P.S.C.U. Docket No. 17-057-09
OCS Data Request No. 4.03
Requested by the Office of Consumer Services
Date of DEU Response August 7, 2017

OCS 4.03: Reference Exhibit 1.3, Excel file data tab:

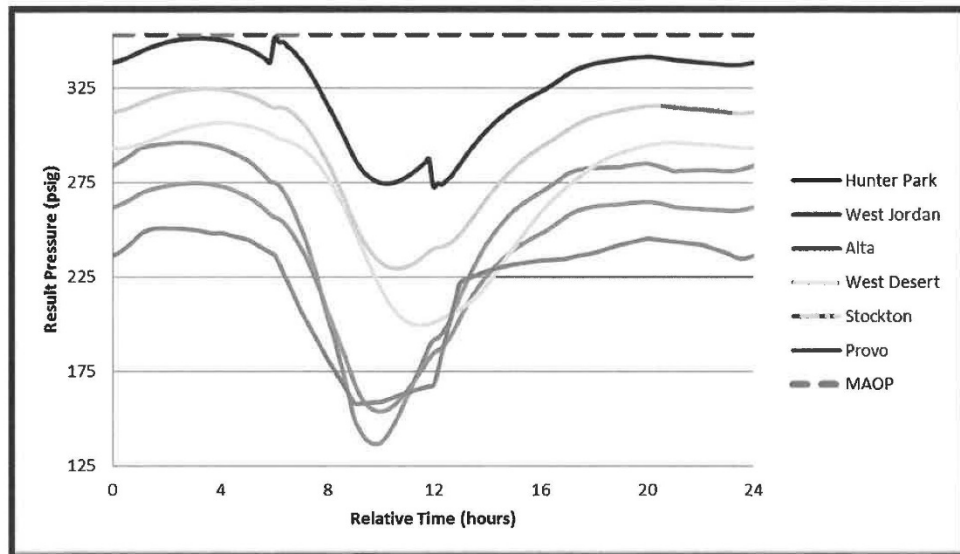
- a. Please explain why the deliveries (1740) in excess of peak hour demands during hours 0 – 5 cannot be used to pack the DEU system and reduce the need for 310 of peak hour service during hour 8;
- b. Please explain why total peak hourly demands for the hours 0 – 23 exceed the total peak day deliveries for hours 0 – 23 by 303; and
- c. Please explain why the Company couldn't begin packing its system prior to hour 0 in anticipation of a peak day.

Answer: a. The Company already uses system pack to feed peak-hour needs. The figure below shows the pressure at Hunter Park along with some of the key points in the same area of the high-pressure (HP) system. The pressures at Hunter Park reach the maximum allowable operating pressure (MAOP) in the early morning, which indicates the system is as packed as is physically possible. When the system is at the peak-hour, the pressures in West Jordan are near operational minimums.

c. Regardless of when the system begins to be packed, when the pressures reach MAOP, additional volumes can no longer be safely accepted into the system. In the figure provided above, the MAOP is reached at Hunter Park prior to the peak-hour indicating that the system is fully packed.
